| To: From: | Jodi S. Hart, CPPO, CPPB, MBA, Chief Procurement Officer _{for} Raj Verma, PE, Director - Public Works <i>Ancisha Danisl</i> |
|------------------|---|
| Re: | Change Order No. 2 for Project No. 12566 |
| Job Description: | Project 12566, North Redundant Sewer Force Main |

EXHIBIT A RFP No. 2

Project: P12566- North Redundant Sewer FM Emergency, Response to #002 - RFP - Existing Pump Stations Connections (Revision 002)

PROPOSED FORCE MAIN CENTERLINE PROFILE

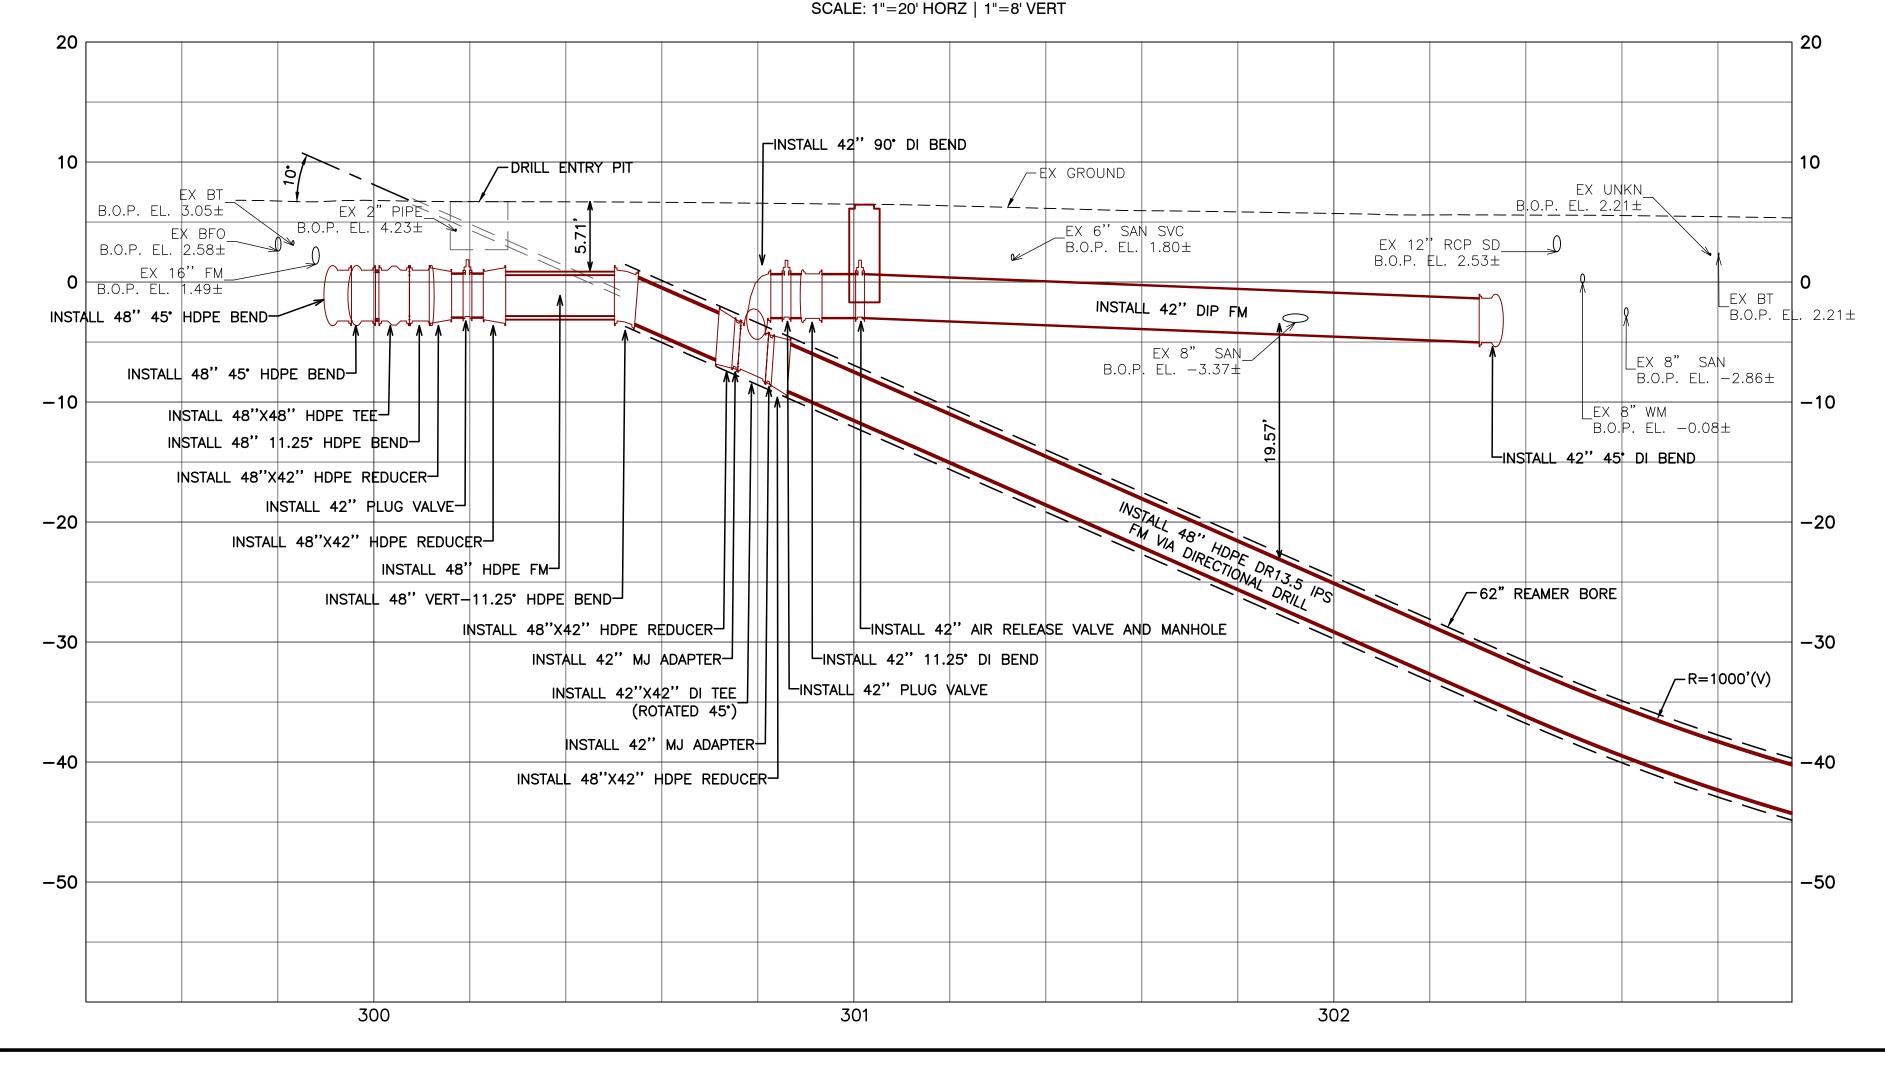
The MPC Team proposes to extend the project limits to 750 LF as indicated in item 1 and showcased in the below aerial.

EXHIBIT D MAP

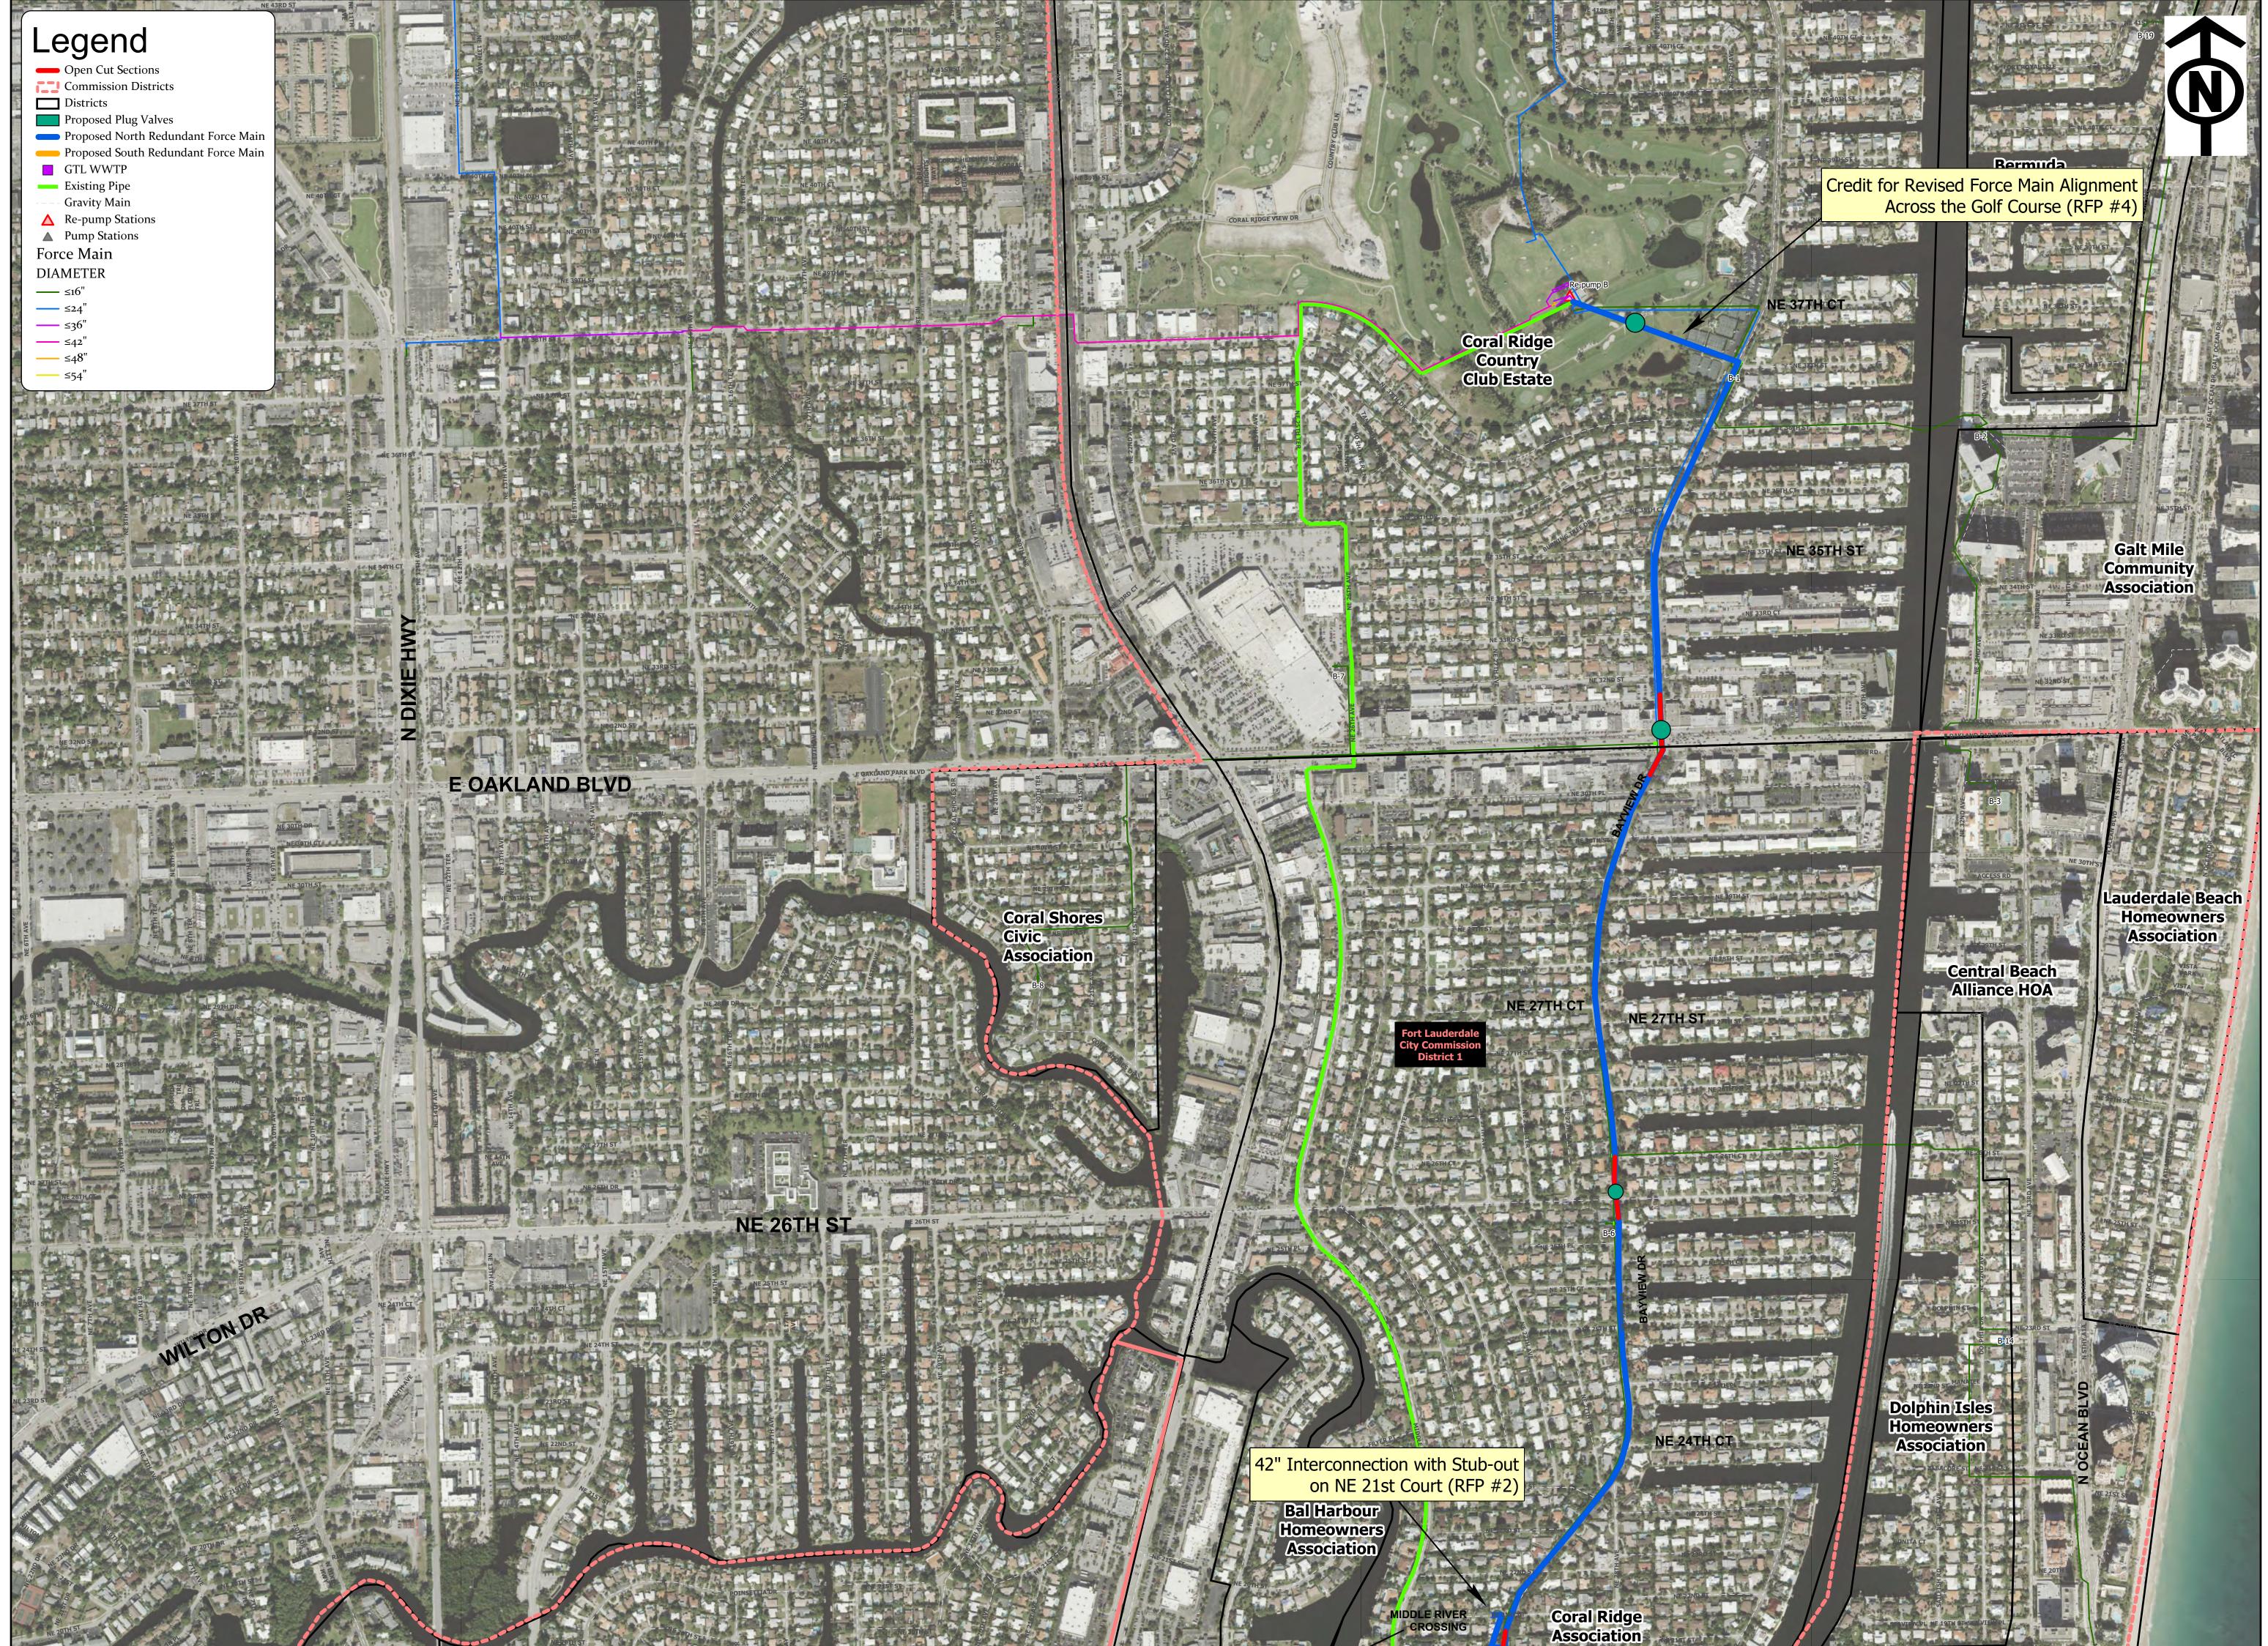
Included as **Exhibit D** is a map showing the location of the proposed work for both RFPs listed above.
